SIGNIFICANT PERMIT REVISION APPROVAL Copy Form

Bank Seam Road Revision

Re: Tank Seam Road and Portal Pad Approval with Eight (8) Stipulations, Bear Canyon Mine, Co-Op Mining Company, ACT/015/025-93B, Emery County, Utah

## TECHNICAL ANALYSIS

# SB-SLOPE

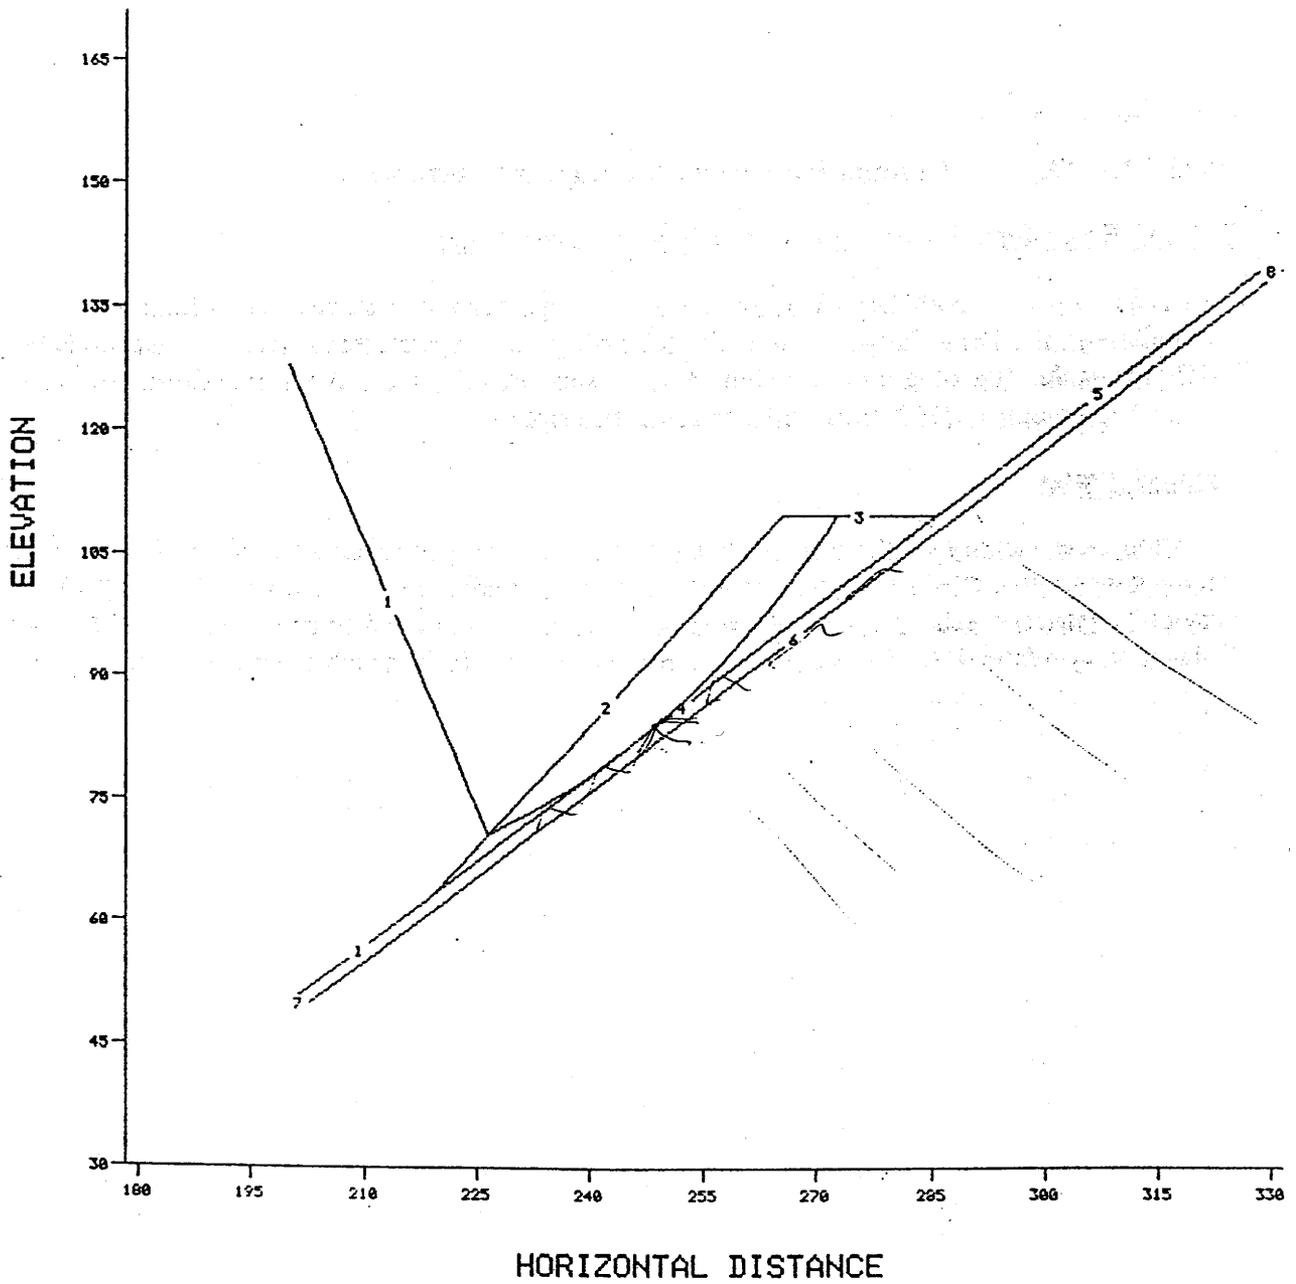
**Fill Slope:** The Division did not agree with the initial Dames and Moore study regarding the fill-slope. Even after the Division added a strong bedrock layer 6 feet under the natural soil the safety factor continued to be 1.1.

When Dames and Moore learned of the low safety factor they revised their assumptions about the slope's profile. They claimed that if the slope was modeled with bedrock steps then the safety factors would be satisfactory. Dames and Moore did not supply the Division with any information on the steps spacing or demonstrate that the steps would prevent failure.

When the Division analyzed the slope using Dames and Moore revised assumptions the safety factor was 1.31. When saturated soil conditions were assumed the safety factor dropped to 1.29. The regulations require road embankments to have safety factors no less than 1.3.

8. The Operator must submit detailed slope profiles and stability analysis for each fill-slope.
